Product Change Notice

PC-WRP-A001B/E (revised Appendix) 2017/03/08

Change Description: Unification of a JEDEC tray and a embossed carrier tape for LQFP package

Tray Pocket cross section

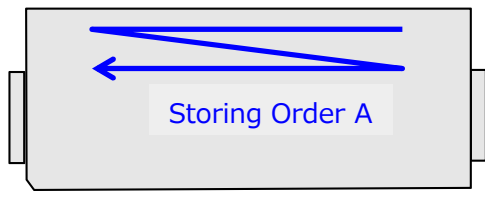
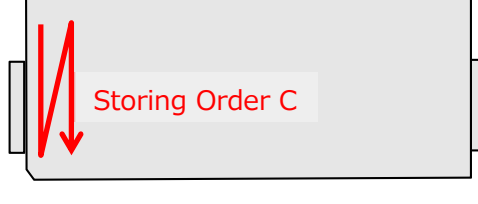
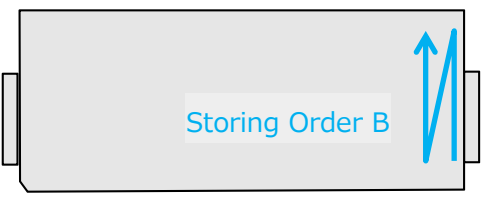
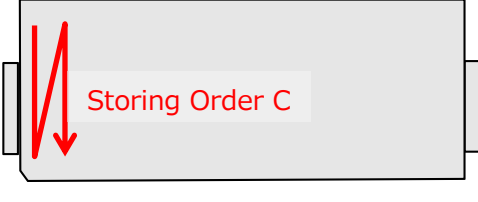
[1-2] Unification of the JEDEC Tray for LQFP Package.

The products shipped by an old model tray shall be changed to a new model tray. A JEDEC specified size (External size, Pocket Pitch, etc.) shall not be changed by this unification, but the seat position may be differed between old and new. The products has already shipped by the new model shall not be changed the tray model. There are a plural pocket shapes (Shape of the pocket hole) at the new tray.

Applied Package	Applied Products	Before		After	
		Old Tray Model	PKG Seat position(mm)	New Tray Model	PKG seat position(mm)
LQFP 7x7	Ref. to APPENDIX_7-2-A	L196-56	2.0	LQFP7x7x1.4	2.0
LQFP 10x10	Ref. to APPENDIX_7-2-B	L196-49	2.0	LQFP10x10x1.4	1.5
LQFP 12x12	Ref. to APPENDIX_7-2-C	JHB-121214	1.5	LQFP12x12x1.4	2.0
LQFP 14x14	Ref. to APPENDIX_7-2-D	L196-05	1.5	TQFP14x14x1.4	2.0
LQFP 16x16	Ref. to APPENDIX_7-2-E	PTB83C	1.8	LQFP16x16x1.4	1.8
LQFP 20x20	Ref. to APPENDIX_7-2-F	L196-65A	2.0	LQFP20x20x1.4	1.6
LQFP 24x24	Ref. to APPENDIX_7-2-G	L196-06A	1.5	LQFP24x24x1.4	1.5

[1-3] Unification of the storing order of IC in the JEDEC Tray

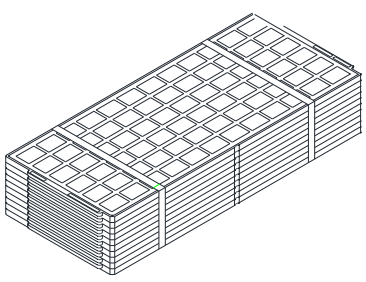
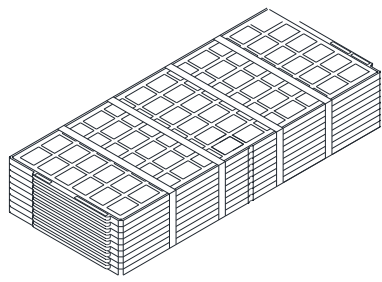
The package storing order to JEDEC tray shall be unified to one direction (Storing Order C) from a plural direction.

Item	Before	After
Storing Order A in the tray		
Applicable products	Ref to APPENDIX_7-3-A

Item	Before	After
Storing Order B in the tray		
Applicable products	Ref to APPENDIX_7-3-B
